#### St Paul Village

Applicant drawings dated 08-04-23

**Design Comments**

Prepared by: Brian Peterson, AIA, Urban Designer, T.O.C.H.

Image 2: Applicant Plan 07-07-23

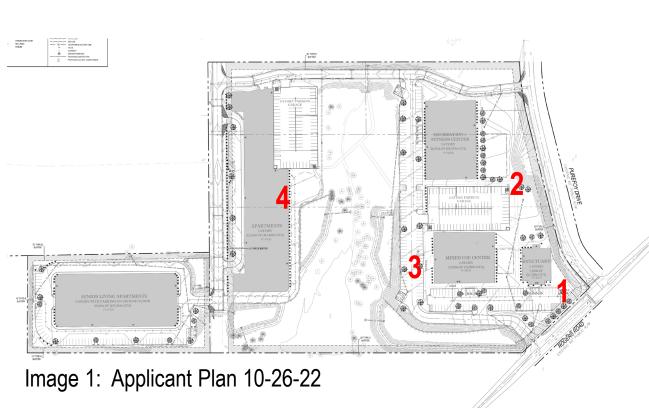
- Suggested moving the Sanctuary building closer to Rogers Road, and to make it an iconic structure architecturally, helping to establish the character of the development. Eliminate surface parking from the corner area.

- 2. The parking garage is creating an un-neighborly frontage along Purefoy Drive. Consider moving the garage to a more interior location on the site. Provide a view of active uses, such as a plaza, that can be seen while driving or walking along Purefoy.

- 3. Reduce surface parking along the central green space. Consider adding a floor to the parking structure to allow for this.
  - 3A. One additional garage floor has been added, the central green space is now fronted by residential buildings looking out onto the green.

- 4. Consider an alternative location for the multifamily building parking structure, one not along the central green. Break down the massing of the large multifamily building by adding courtyards and articulating the façade into vertical modules.

- 1A. The Sanctuary building has been relocated to the corner and angled to make a more visually appealing "gateway" into St. Paul Village. The angling motif has been applied to other buildings along the main internal street, which helps break down the scale of the larger buildings and adds some dynamism to the massing. A green space has replaced the surface parking at the corner of Purefoy and Rogers Road, a significant improvement.

- 2A. The parking garage has been moved inward on site, and wrapped on three sides with housing, vastly reducing the visual impact of the parking structure from the Purefoy frontage. The frontage along Purefoy is now lined by a linear green space, and buildings with commercial, retail, and community uses. This appropriately places the most public uses along the principal public frontage. A "village center" has been provided as one first enters the site, and is viewable from Purefoy, and can become a focal point for residents and visitors to St. Paul Village as well as those who live in the adjacent neighborhoods. At the eastern portion of the Purefoy frontage, a small park helps transition into the adjoining residential neighborhoods.

- 4A. The parking structure is relocated to the street edge, freeing up the green space frontage for residential uses. The massing of the building has been broken down by the provision of courtyards facing the green. Additional vertical modules help reduce the mass. Further studies of articulation and material selection should continue to explore means to reduce the visual bulk and length of the building.
